<div>LANGE Aviation</div>	<div>Lange Aviation GmbH Brüsseler Straße 30 D-66482 Zweibrücken</div>	<div>Technical Note Nr. 904-5</div>	<div>Seite Page TN 904-5/1 Von of 18</div>
<div>TN 904-5</div> <div><div>Subject:</div><div>Shaft-coupling in pump-unit</div></div> <div><div>Affected::</div><div>E1 Antares, 1 to 60E49</div></div> <div><div>Date:</div><div>20.03.2014</div></div> <div><div>Urgency:</div><div>Before next flight</div></div> <div><div>Reason:</div><div><div>There have been cases where the shaft-coupling, which connects the shaft of the electric motor with the shaft of the hydraulic pump, has broken.</div><div>This leads to the loss of the ability to extend and retract the motor, and the ability to retract the landing gear. It is still possible to extend the landing gear.</div></div></div> <div><div>Actions:</div><div>Carefully read through the entire Technical Note prior to the implementation of the described actions.</div></div> <div><div>TN 904-5 replacement of the shaft-coupling in pump-unit</div><div>The following procedural steps must be performed:</div><div><div>1. Extend the motor and leave it in maintenance position (motor extended, motor bay covers open) as desc

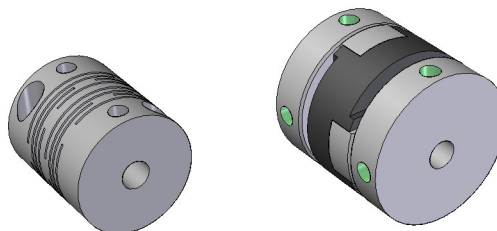
- c. Use a 7 mm wrench to loosen the clamp (4), which fix the motor cover (5) to the coupling enclosure (6).
- d. Slide the coupling enclosure and the clamp so far to the back that the forward aperture in the coupling enclosure is exposed. Look through the aperture to identify the coupling.

If the installed coupling is identical to coupling (1) in the picture above, then this must be replaced. If the installed coupling is identical to coupling (2) in the picture above, then the procedural steps 4e to 8p are skipped.

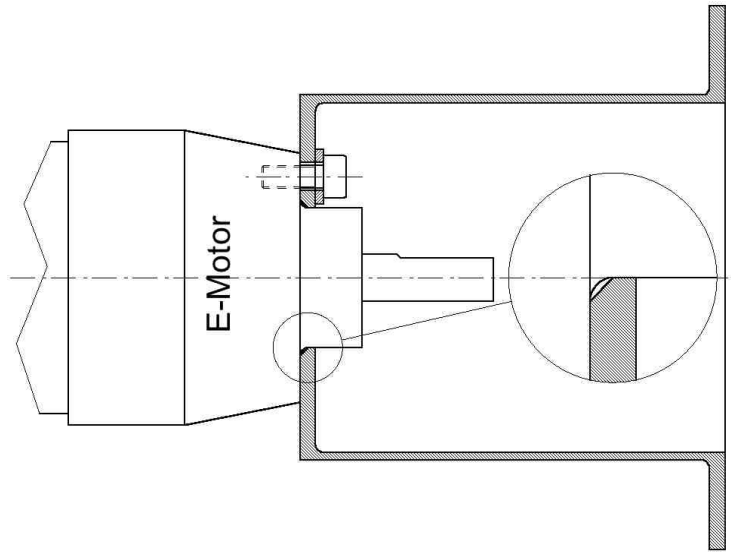
Check whether there is a gap between the motor and the coupling enclosure. If this is the case, then use a 2 mm Allen wrench to remove the four M3 x 8 screws (15), which connect the motor and the coupling enclosure.

Separate the motor from the coupling enclosure and use a 90° countersink tool to fit the edge of the coupling enclosure to the radius at the motor. Before re-assembly: check the length of screws (15) (Screw length should be 8 mm). Re-install the motor. Use medium strength threadlocker (Loctite 243) on the screws and apply inspection lacquer

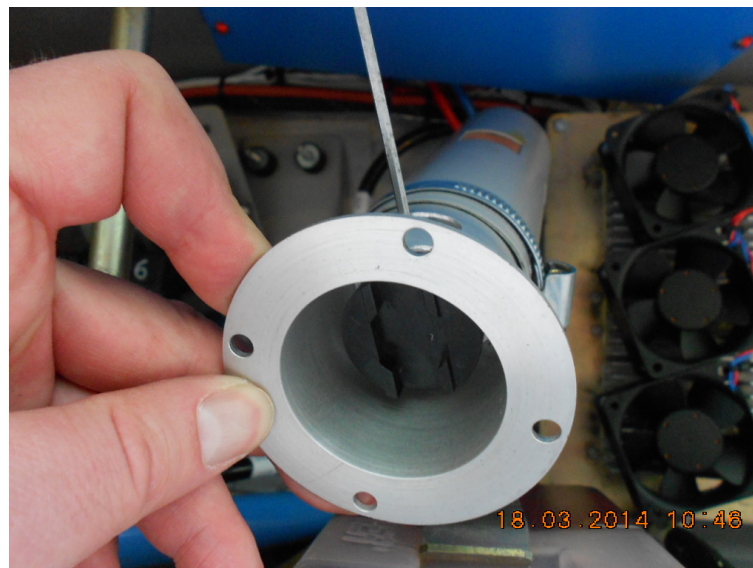
- e. Use a caliper rule to position subassembly A, conforming to the illustration above, at a distance of 26 ± 1 mm away from the bottom surface of the coupling enclosure.
